Advisory Board on Radiation and Worker Health
National Institute for Occupational Safety and Health

Summary of Key Issues Concerning Internal Monitoring Completeness and Representativeness for SRS Subcontractor Construction Trade Workers

**Contract No. 75D30119C04183
Document No. SCA-TR-2021-SEC002, Revision 0**

March 8, 2021

Figure 1. Fraction of sCTWs monitored for non-H3 radionuclides compared to total including tritium

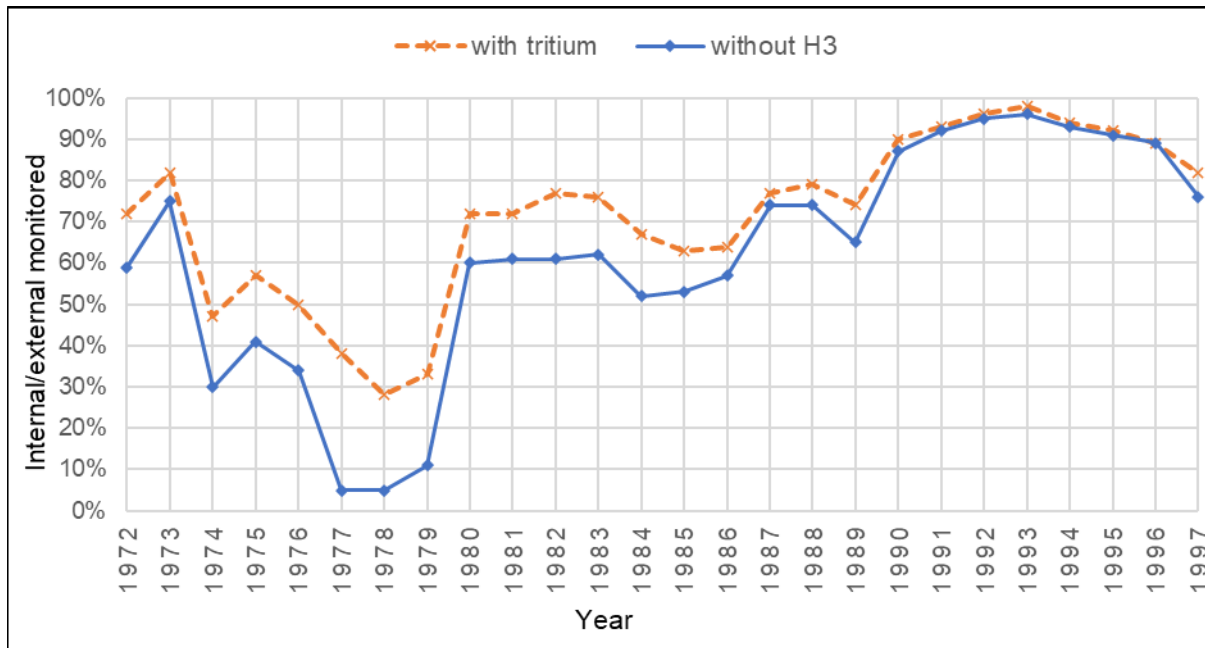
To clarify the fraction of sCTWs monitored for non-tritium intake, SC&A analyzed the data in tables 5-3 and 5-4 of RPRT-0094. Figure 1 shows the percent of sCTWs with external monitoring who also were monitored for internal intakes (with and without tritium bioassay).

Note that for a significant number of years, the fraction of sCTWs internally monitored decreased when going from using all internal monitoring methods, which includes tritium bioassays (top plot), to non-H3 monitoring (bottom plot), especially during the 1970s and 1980s.

Finding 1: SC&A does not believe it is appropriate to combine tritium bioassay monitoring with other dosimetrically significant radionuclide monitoring, nor does SC&A feel it is appropriate to average values over multiple years in assessing the general completeness of internal monitoring for the subcontractor claimant population. Internal tritium monitoring was specifically omitted from the RPRT-0092 analysis of RWPs and followup job-specific monitoring as not relevant.

Figure 2. Percentage of externally monitored subcontractor claims with plutonium bioassay in same year

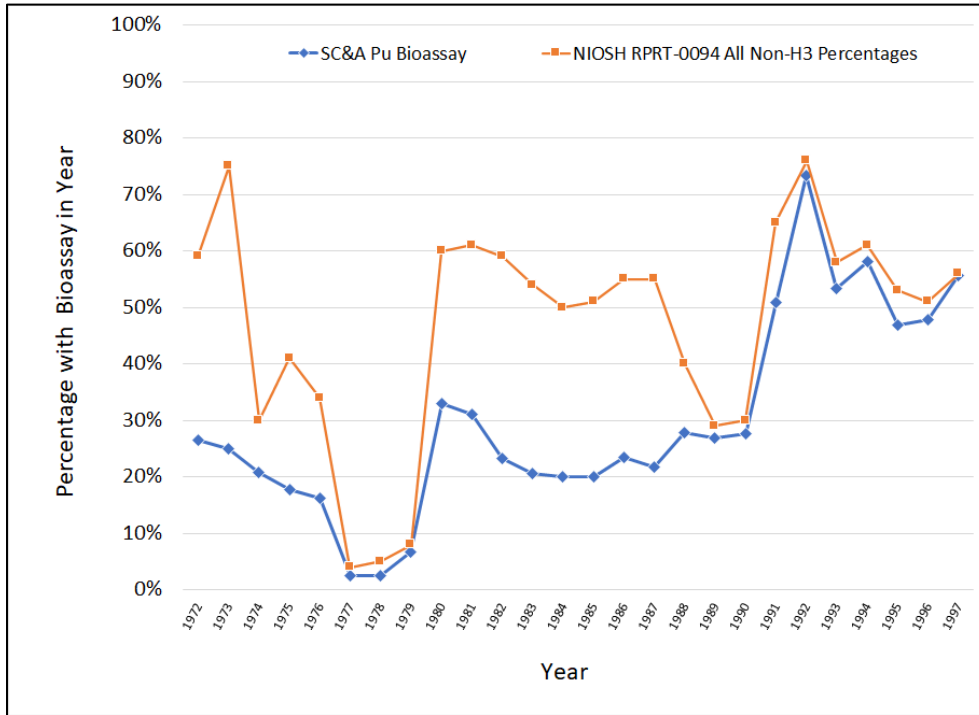
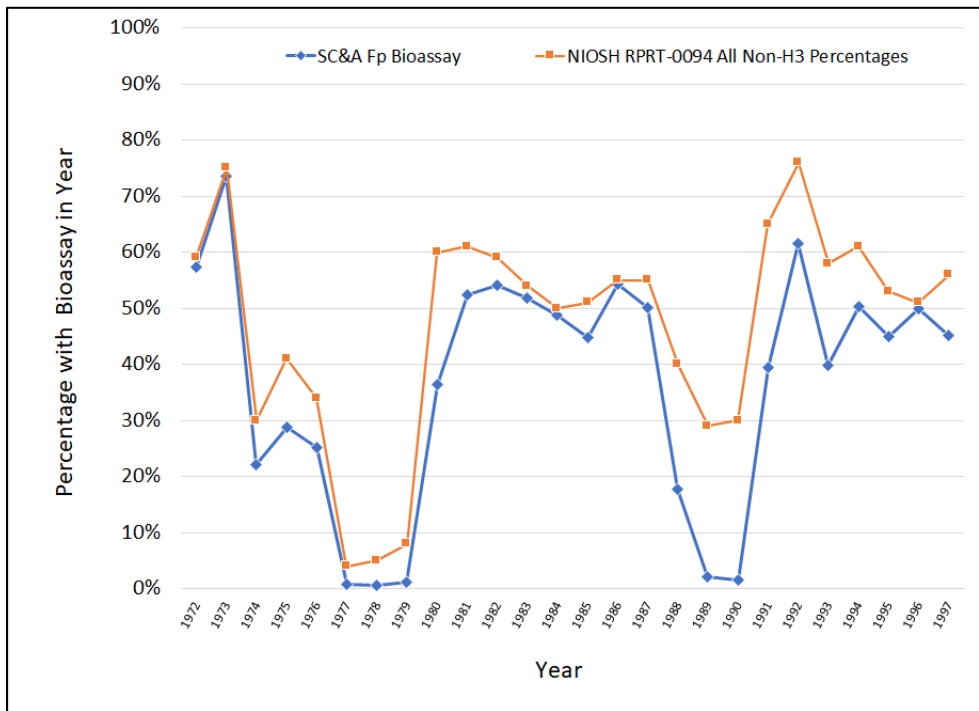
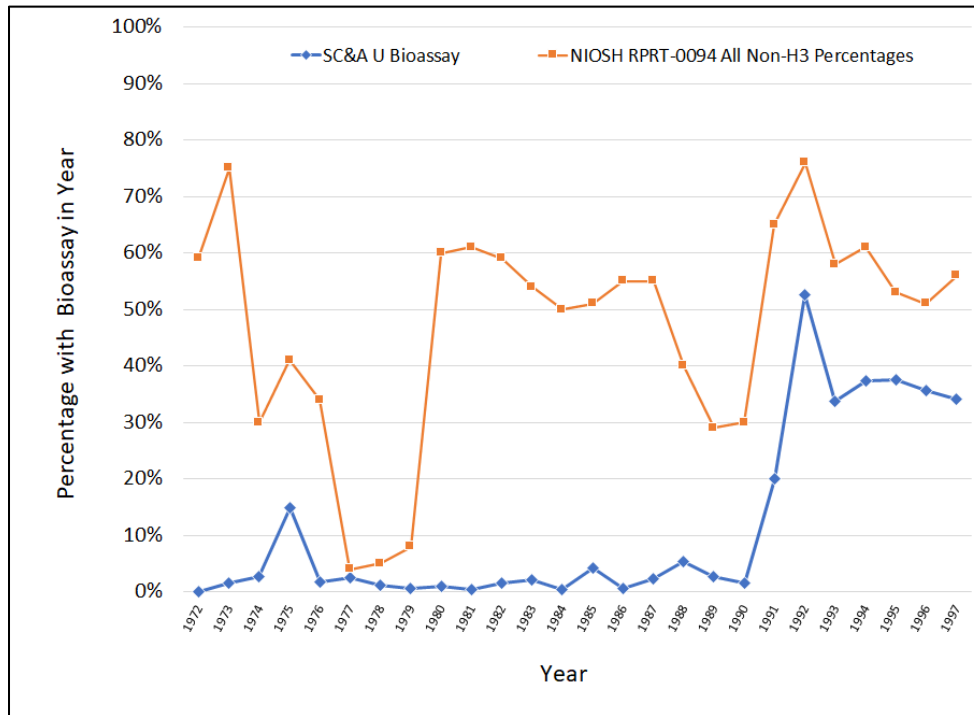
As shown in figure 2, plutonium bioassay coverage ranged from 2.4 percent in 1978 to 73.1 percent in 1992; however, if only the DuPont era⁴ of interest is considered, the maximum percentage drops to 32.8 percent in 1980. Figure 3 shows that fission product bioassay coverage ranged from 0.6 percent in 1978 to 72.5 percent in 1973. Figure 4 shows that uranium bioassay coverage ranged from 0.0 percent in 1972 to 52.4 percent in 1992; however, if only the DuPont era of interest is considered, the maximum percentage drops to 14.7 percent in 1975. For comparison, the far-right column of table 1 (column 7) shows the percentage of workers monitored for all non-tritium bioassay as provided in table 5-3 of RPRT-0094. The RPRT-0094, table 5-3, results are also plotted in figures 2–4 to illustrate the individual differences for these radionuclides.

Not surprisingly, the RPRT-0094 percentages for all non-H3 bioassay are significantly higher than the SC&A evaluation for many years and radiation types. This is particularly evident for many years during the DuPont era. However, beginning in 1988, the bioassay percentages calculated by SC&A show significantly better agreement with the RPRT-0094 percentages for non-H3 bioassay. SC&A observes that during this latter period, often plutonium, uranium, and fission product bioassay were all collected on the same date for the individual worker.

Finding 4: When non-tritium bioassay is separated into the individual radiological assay components (plutonium, fission products, uranium, neptunium, and americium), the percentage of monitored subcontractor workers decreases markedly for many years during the DuPont era.

Figure 5. Comparison of the number of subcontractor claims with external dosimetry associated with 773-A versus those also monitored via americium urinalysis per year

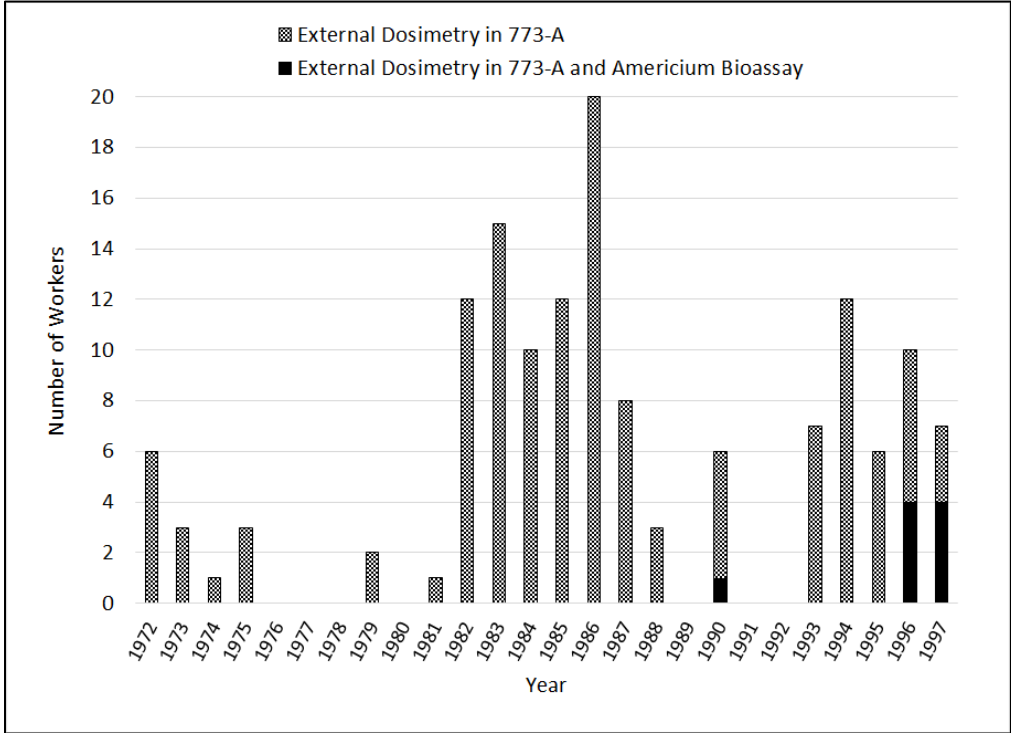
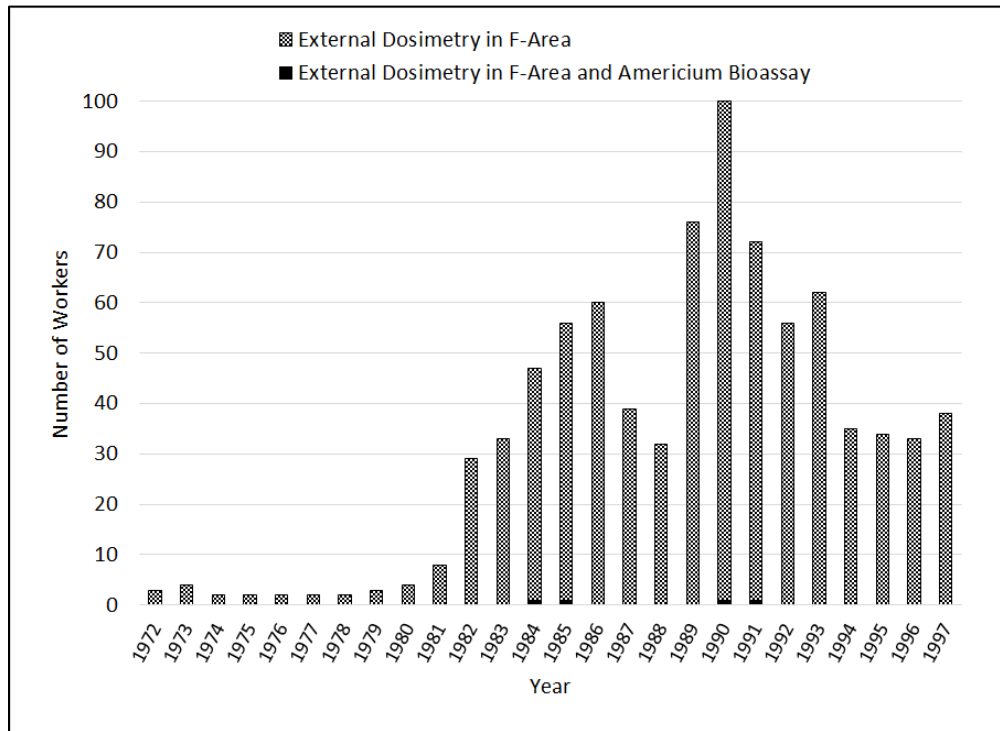
The percentage of workers with observed dosimetry and bioassay results for americium is shown in figures 5 and 6 for 773-A and F-Area, respectively. As seen in figure 5, americium bioassay and 773-A dosimetry matches were only observed in 1990 (16.7 percent), 1996 (40 percent), and 1997 (57.1 percent). It is noteworthy that the percentage of monitored workers in 773-A in 1990 (16.7 percent) reasonably matches the percentage of monitored workers identified with 773-A F-

Specific to the F-Area (figure 6), external dosimetry and americium bioassay matches were only observed in 1984 (2.1 percent), 1985 (1.8 percent), 1990 (1.0 percent), and 1991 (1.4 percent). It should be noted that while the MPPF was constructed in 1972, the facility did not appear to start full operations until approximately 1978. It is also not clear what level of operation occurred at the MPPF throughout the period of interest and whether there were significant periods where the facility was shut down and/or placed in standby mode.

Observation 1: A limited, area-specific analysis of dosimetry codes with americium bioassay showed a very low percentage of bioassay coverage with the exception of 1996 and 1997 (40 percent and 57.1 percent monitored via bioassay, respectively) for the 773-A area. The other year in which 773-A specific dosimetry and bioassay matches were identified (~17 percent in 1990) showed a reasonably similar percentage to the RWP analysis described in RPRT-0092 during the DuPont era (20 percent directly monitored via urinalysis or chest count for 1981–1988).

Figure 7. Summary of in vivo counting methods

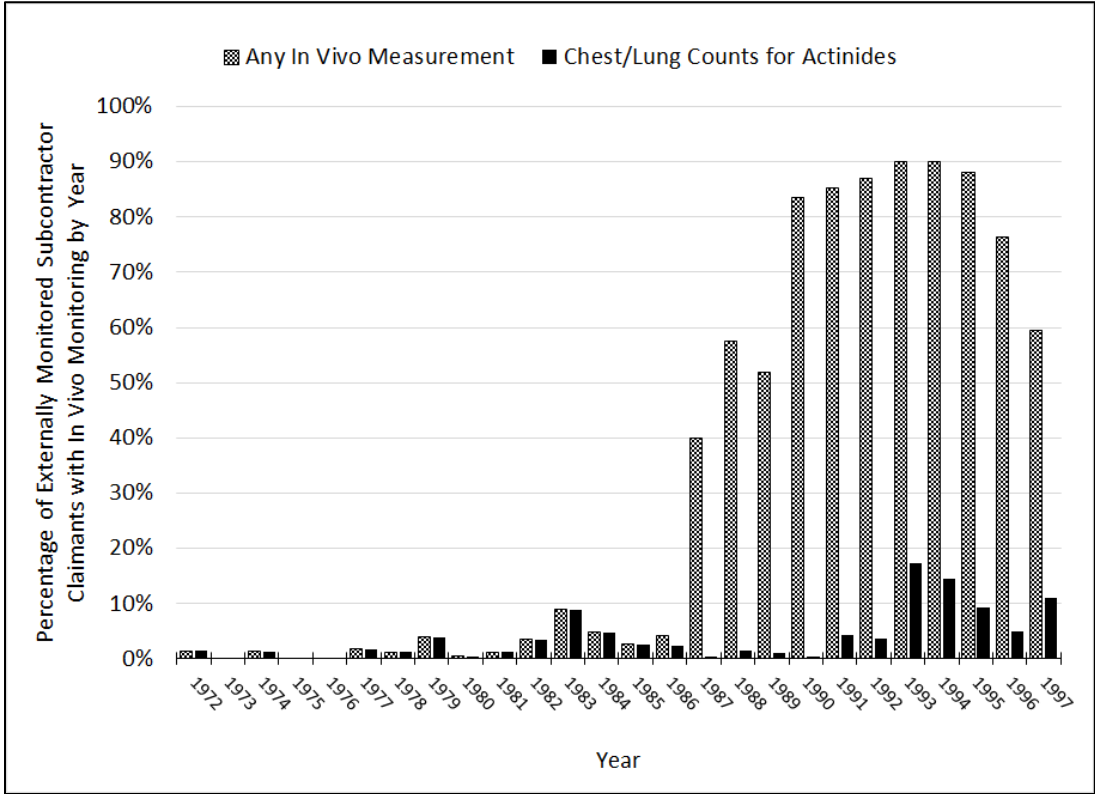
A breakdown, by year, of the number of claimants with external dosimetry and in vivo monitoring is shown in table 2 and plotted in figure 7. As seen in the table, overall in vivo

monitoring was somewhat infrequent until 1987 (generally less than 5 percent of the externally monitored population). The marked increase in 1987 coincides with the implementation of the FASTSCAN counter, which was capable of performing diagnostic measurements of individuals in a matter of 1–2 minutes but was not capable of measuring lower energy photons associated with the actinides of plutonium and americium. Chest counting (which is capable of measuring actinide material) during the DuPont era was also relatively infrequent, with the percentage monitored ranging from lows of 0 percent in 1973, 1975, and 1976 to a high of 8.9 percent in 1983. The percentage monitored via chest count was less than 5 percent for all other years during the DuPont era.

Observation 3: Chest counting capable of measuring actinide material, such as americium and plutonium, was relatively infrequent during the DuPont era and was generally less than 5 percent of the externally monitored population. Therefore, the effect on the monitoring totals for these contaminants is minimal for most years (refer to section 7 for a full analysis).

Figure 8. Combined monitoring coverage (in vitro plus in vivo) for major radionuclide categories

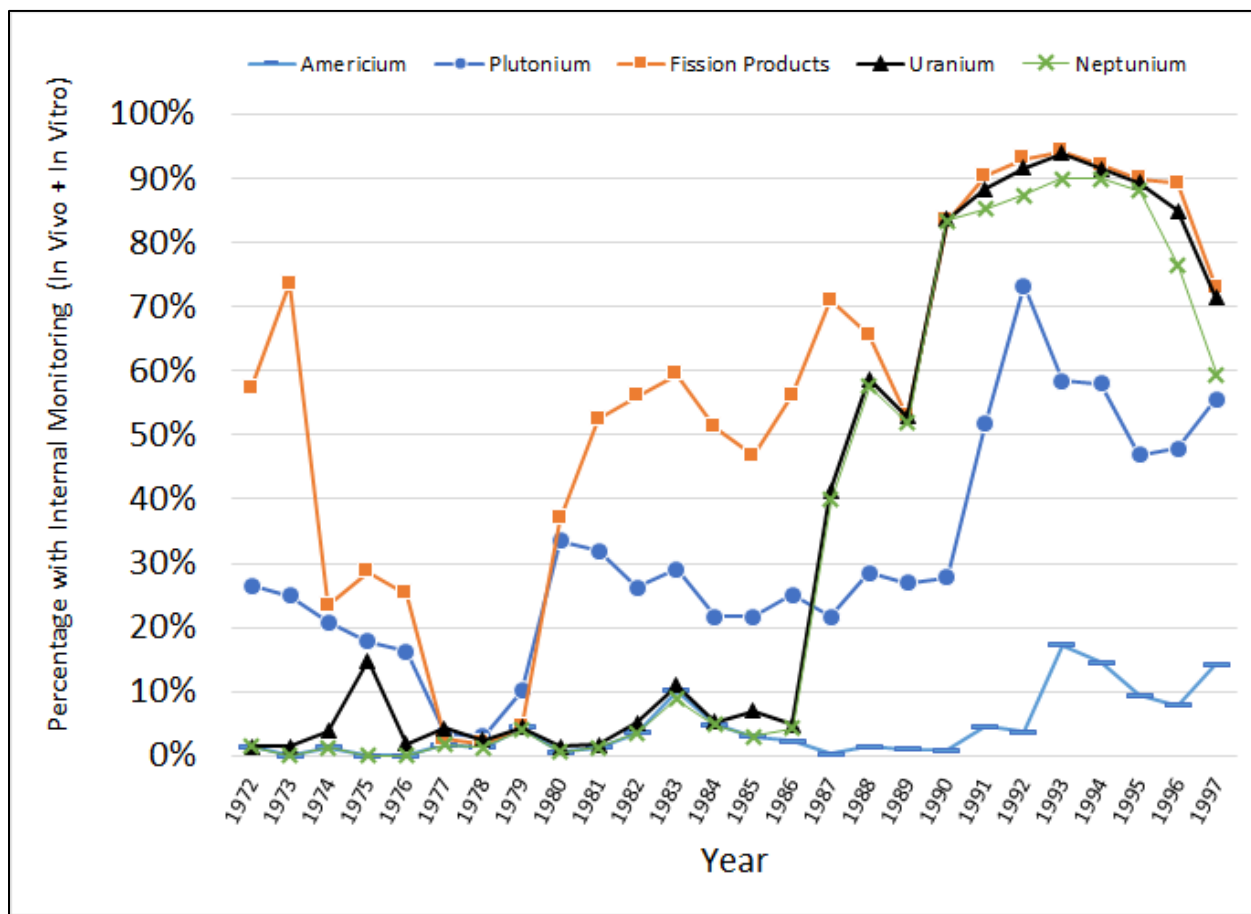
Finding 5: When considering both relevant in vitro and in vivo data, the percentage of plutonium and americium monitoring coverage during the DuPont era (1972–1990) only ranged 3–34 percent and 0–10 percent, respectively. This can be compared to the range of 5–87 percent calculated for all non-tritium bioassay in RPRT-0094.

Table 5 and figure 8 present the combined internal monitoring coverage by year. They show that, on a year-by-year basis, plutonium bioassay coverage was generally less than 30 percent of the NOCTS subcontractor population until 1991. For the other radionuclides (excluding americium),

Figure 9. Comparison of the number of subcontractor claims with external dosimetry associated with 773-A versus those also monitored via americium urinalysis or chest counts per year

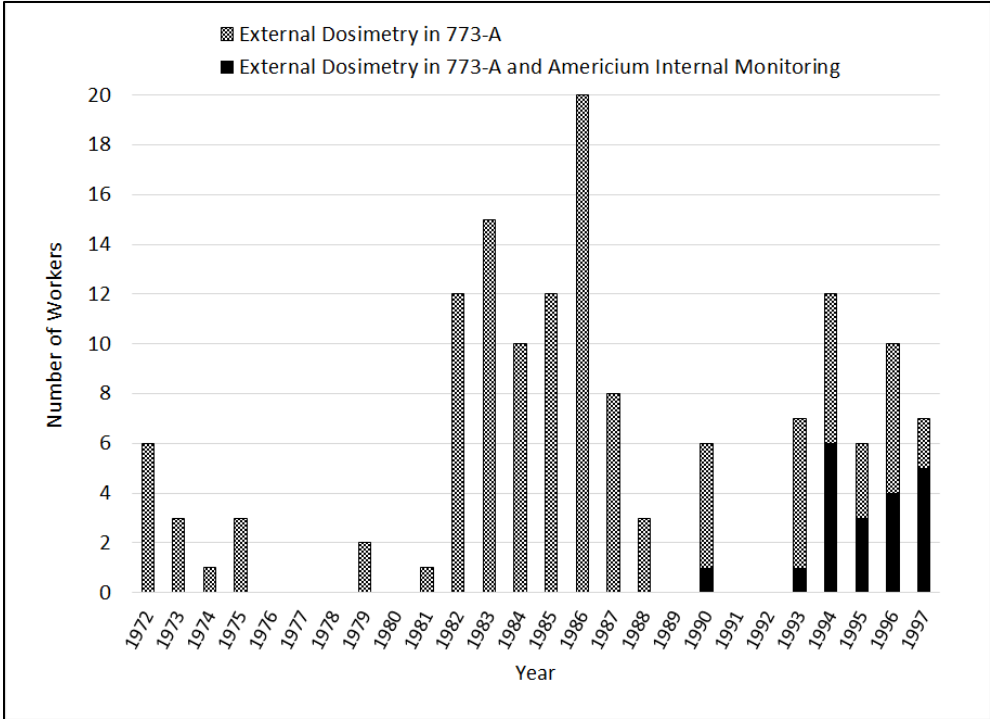
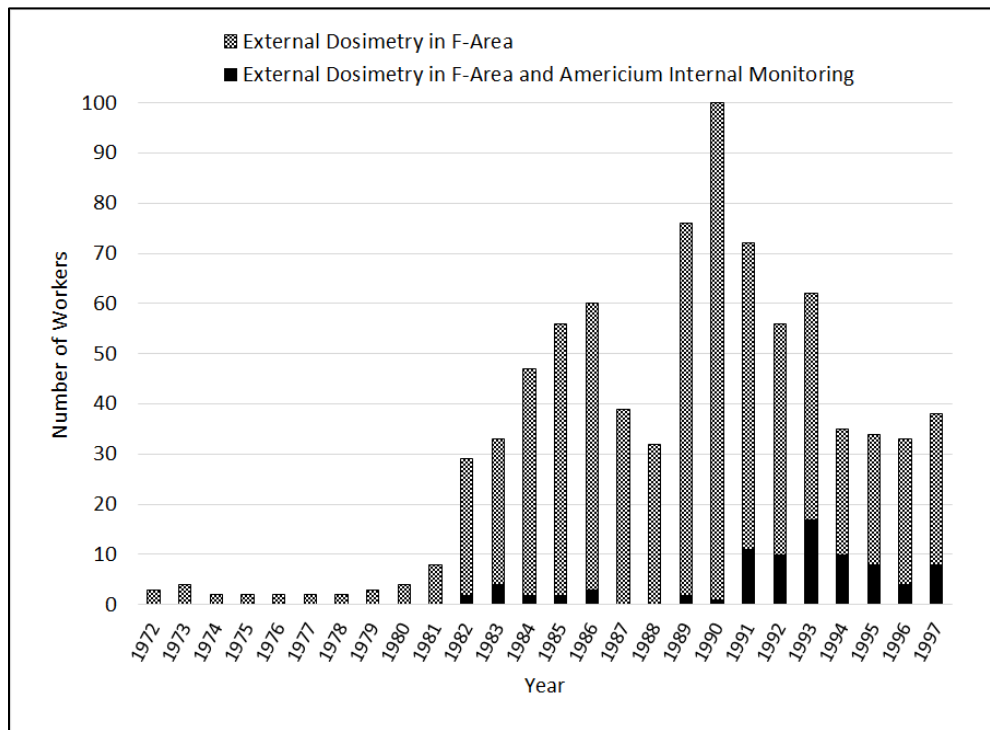
Similar to the analysis in section 5, SC&A performed an area-specific analysis for americium based on external dosimetry codes for 773-A and F-Area. The results are shown in figures 9 and 10. As seen in the figures, the inclusion of chest count data had a significant effect for the 773-A area during certain years of the WSRC era, with americium monitoring percentages ranging from 40 percent to 70 percent in the years 1994–1997. For the F-Area analysis, americium monitoring coverage ranged from 0 percent (1972–1981, 1987, and 1988) to

Observation 5: Similar to observation 1, a limited, area-specific analysis of dosimetry codes with americium bioassay showed a very low percentage of bioassay coverage, with the exception of the late 1990s for the 773-A area. For the F-Area analysis, monitoring percentages were zero for 12 of 26 years evaluated and less than 20 percent for 22 of 26 years (including the 12 zero percentage years).
